UNITED STATES PATENT AND TRADEMARK OFFICE

APPLICATION NO.	FILING DATE	FIRST NAMED INVENTOR	ATTORNEY DOCKET NO.	CONFIRMATION NO.
09/989,277	11/20/2001	Frederic Lagace	CLW 2 0098-1-2	1192

Office Action Summary

Figure A: The modified figure corresponds to figure 1 with limitations shown.

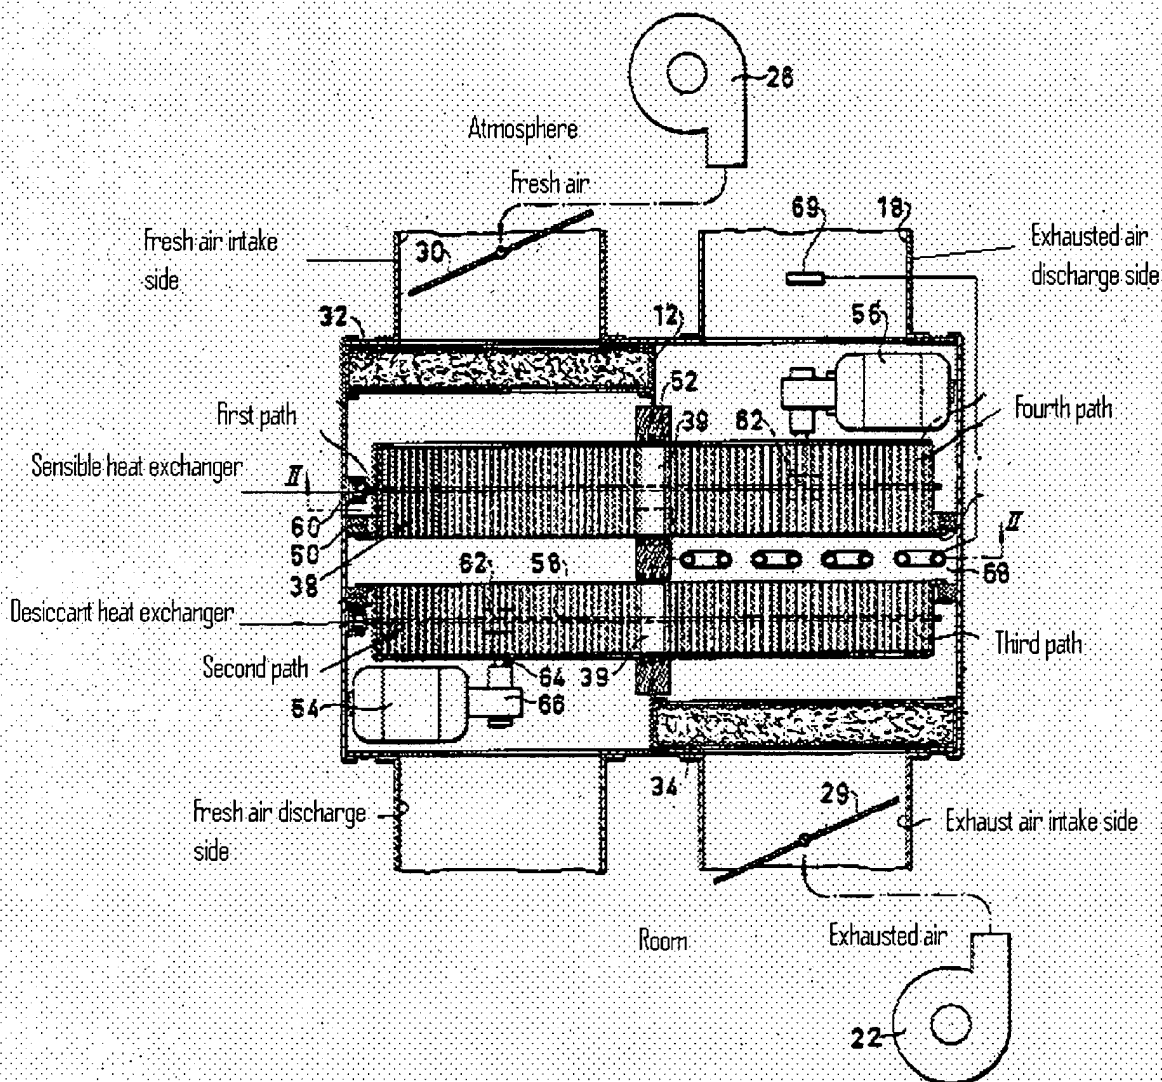
Claims 35-36 and 38-39 are rejected under 35 U.S.C. 102(b) as being anticipated by C. G. Munters et al. (US 3,125,157). Munters discloses (figures 1,2, A and column 2, line 39 –

column 4, line 50) the ventilation apparatus and the method for exchanging air between the interior and exterior of a building.
